Well Name: BISTI COAL 4 COM	Well Location: T25N / R12W / SEC 4 / NWSW / 36.427444 / -108.12236	County or Parish/State: SAN JUAN / NM
Well Number: 2	Type of Well: OTHER	Allottee or Tribe Name: EASTERN NAVAJO
Lease Number: 1420603321	Unit or CA Name: BISTI COAL 4 COM	Unit or CA Number: NMNM86369
US Well Number: 3004528196	Well Status: Producing Gas Well	Operator: DJR OPERATING LLC

Notice of Intent

Type of Action: Plug and Abandonment

Plug and Abandonment Procedure
for
DJR Operating, LLC
Bisti Coal 4 Com 2
API # 30-045-28196
NW/SW, Unit L, Sec. 4, T25N, R12W
San Juan County, NM

**DJR Operating, LLC
Proposed Wellbore Diagram**

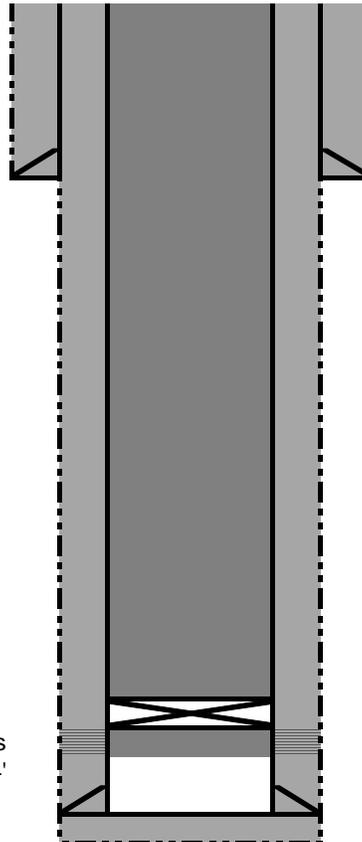
You are also required to place cement excesses per 4.2 and 4.4 of the attached General Requirements.
